THE VILLAGE

MASTER PLAN

LUSTER
THE VILLAGE
MASTER LANDSCAPE PLAN

LUSTER THE VILLAGE	
VICINITY MAP	
ENGINEERING <small>RESOURCE GROUP, P.C. 380 E Main St. Suite 204, Midway, UT 84049 ph: (435) 657-9749</small>	
DESIGN BY: CNB	DATE: 31 MAR 2021
DRAWN BY: CNB	REV: 1

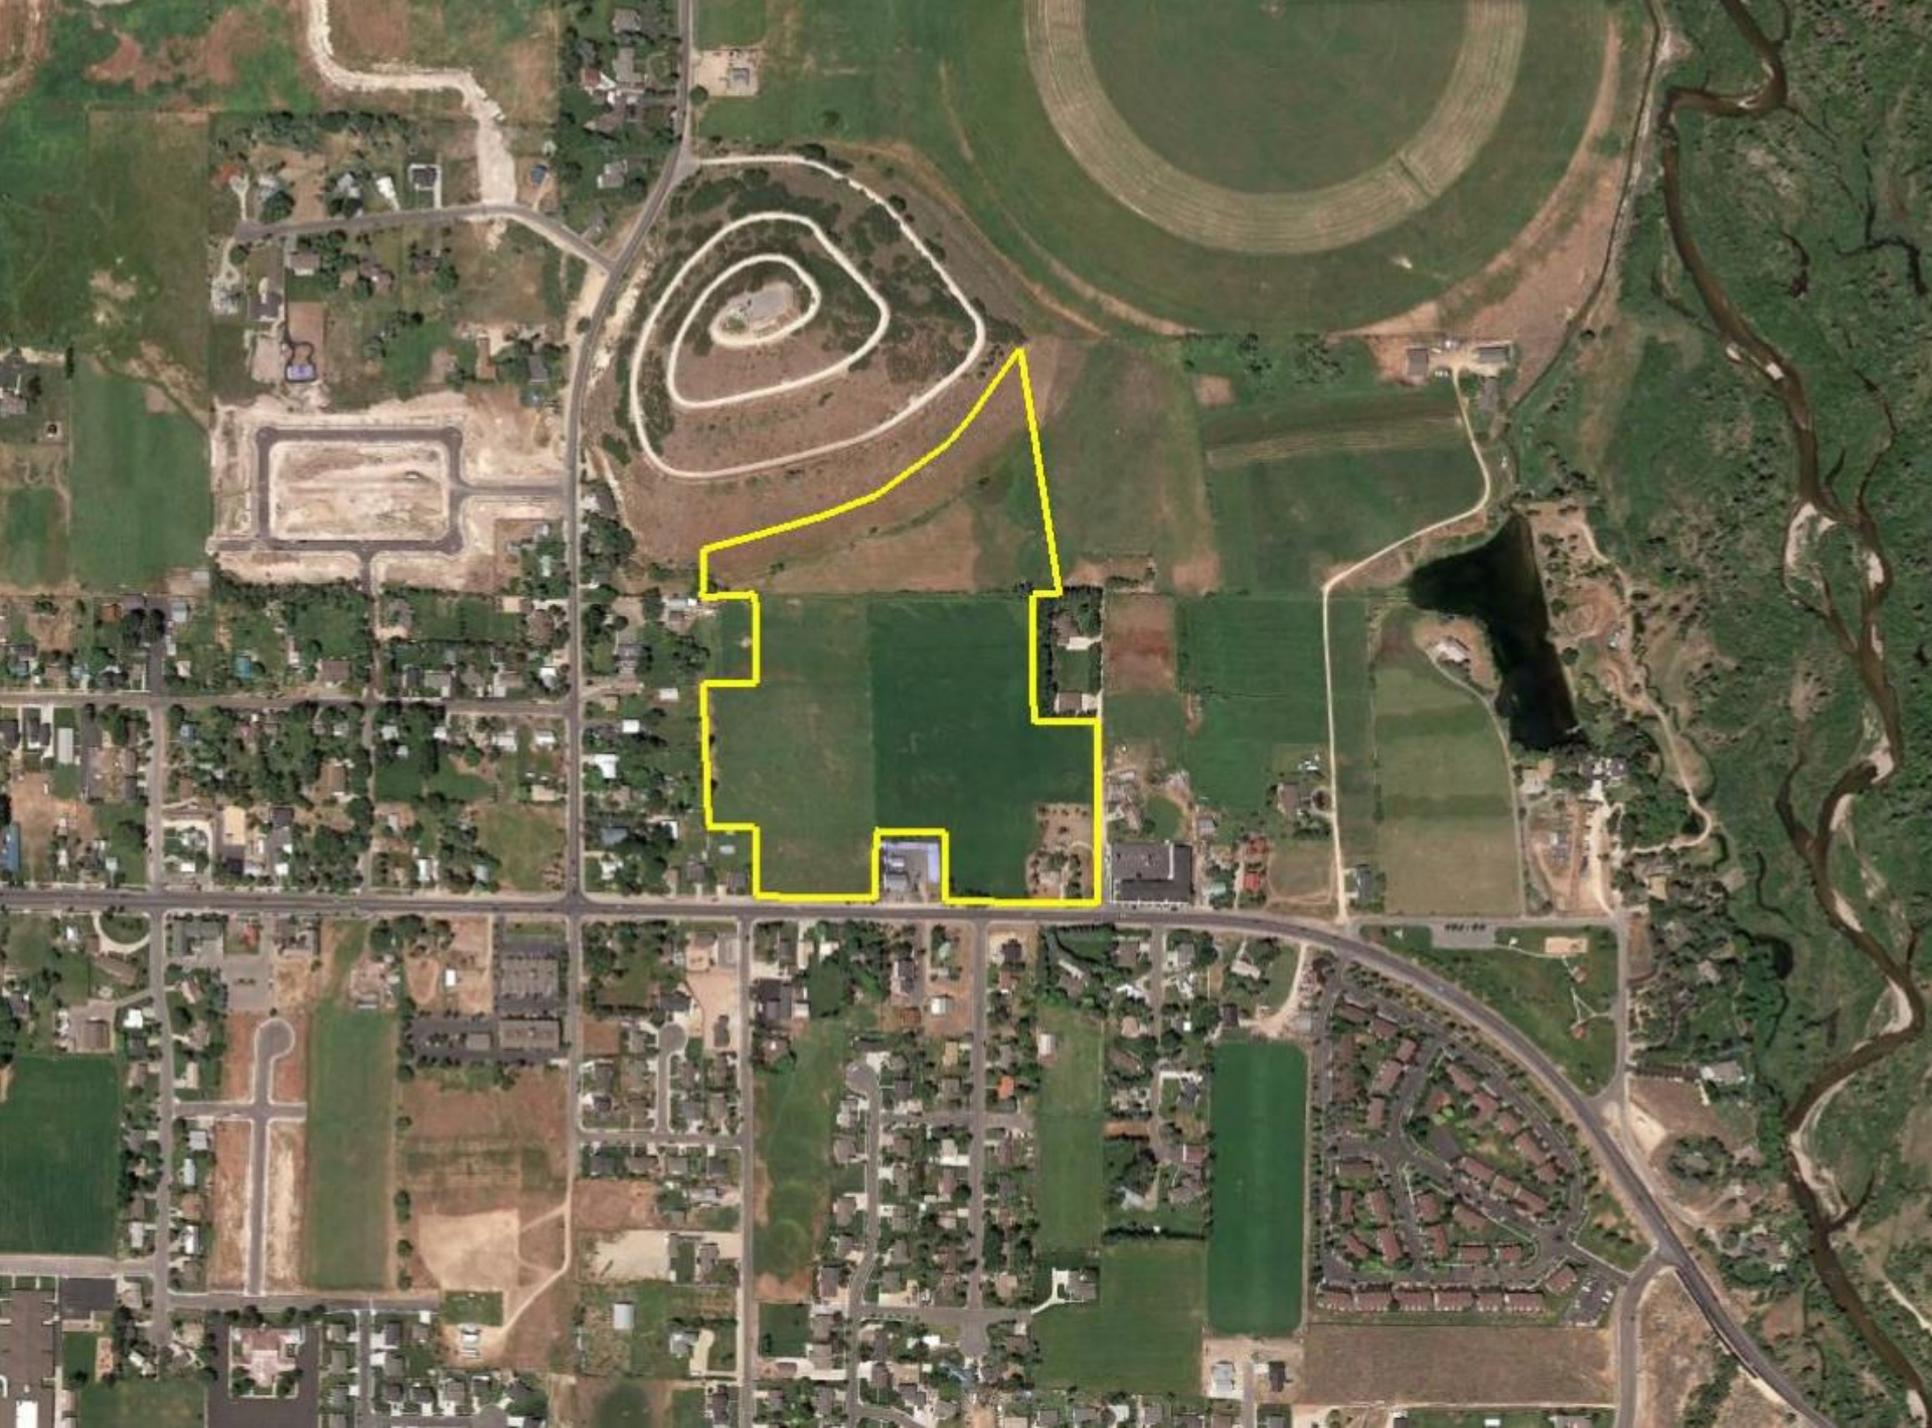
PROPOSED RIVER ROAD ACCESS - THIS ROAD WILL MAINTAIN A LEVEL OF SERVICE D AT MAIN STREET WITHOUT A TRAFFIC LIGHT

RIVER ROAD AND MAIN STREET INTERSECTION WARRANTS A TRAFFIC LIGHT PER UDOT CRITERIA. IF TRAFFIC LIGHT IS INSTALLED SOON THE RIVER ROAD ACCESS FOR THE DEVELOPMENT MAY NOT BE NECESSARY.

LUSTER THE VILLAGE
 MASTER PLAN

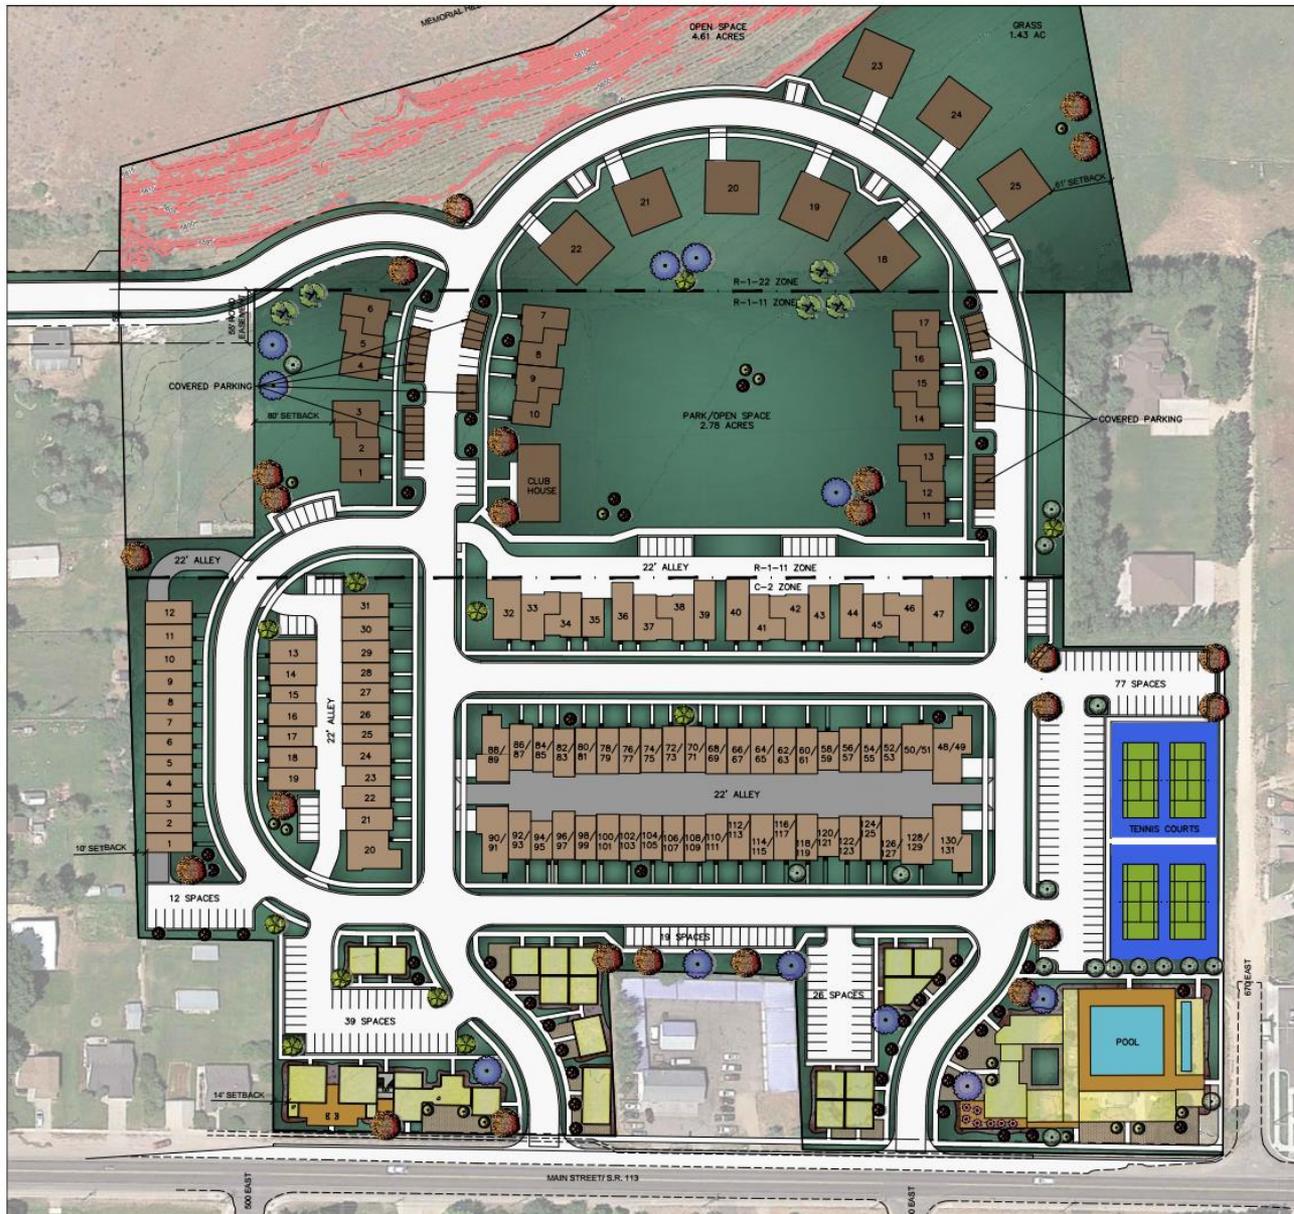
- Roads and traffic circulation
 - 3rd access added to River Road
 - Public roads except for phase 6
- Traffic study
 - Possible off-site improvements
- Alley access
 - Snow removal
 - Trash removal

- Main Street improvements
- Public Participation Meeting
 - March 4, 2021
- Trails
- Architectural Theme
- Parking
 - Residential complies with requirements
 - Commercial, depending on the use, can meet the requirements

- Density
 - C-2 zone
 - 13.29 acres
 - 131 units
 - R-1-11
 - 5.77 acres
 - 17 units
 - R-1-22
 - 7.64 acres
 - 8 units

PHASING PLAN

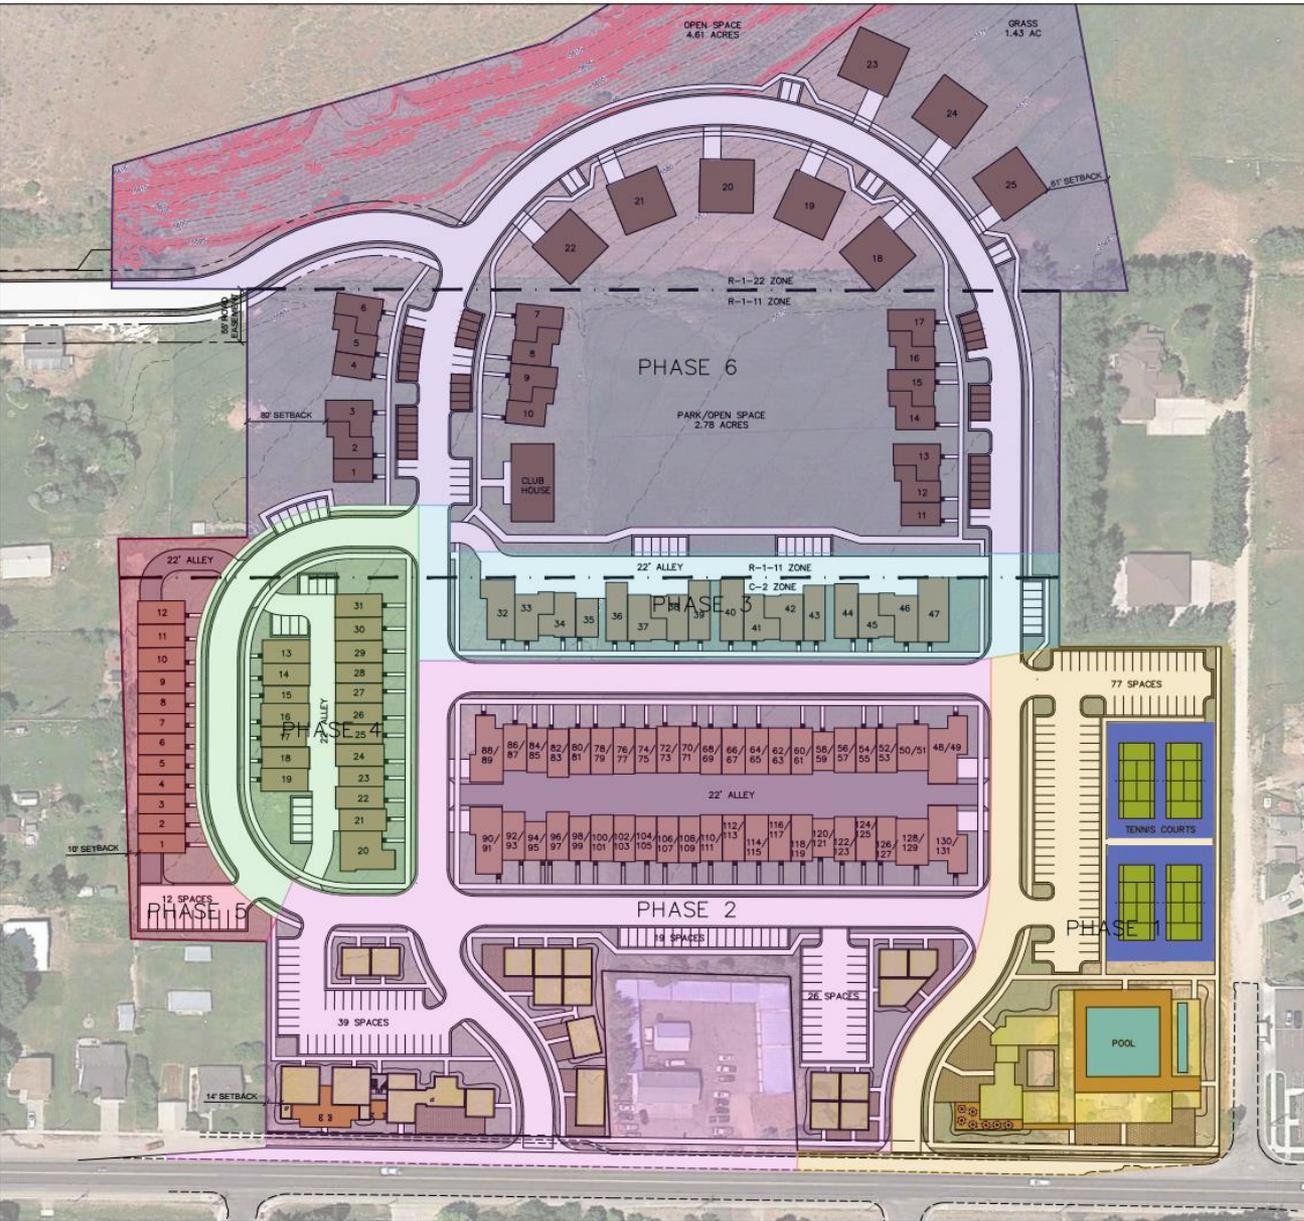
- Required commercial square feet
 - Commercial includes 3 floors
 - 63,250 square feet (20%)
 - Residential includes all the square feet in the structure
 - 252,998 square feet (80%)
- To assure that the commercial square feet requirement is met, staff is proposing that approvals of phases 4 and 5 (which are fully residential) are not approved for preliminary approval until the commercial structures are built.

- Phases 3, 4, and 5 cannot be recorded until the correct ratio of commercial has been built to allow for the residential to be approved.
- Setbacks
- Height of structures
- Transient Rental Overlay Zone (TROD)
- All phases are required to be part of one Property Owners Association (POA)
- Water table
 - Ability to build basements and lower-level parking
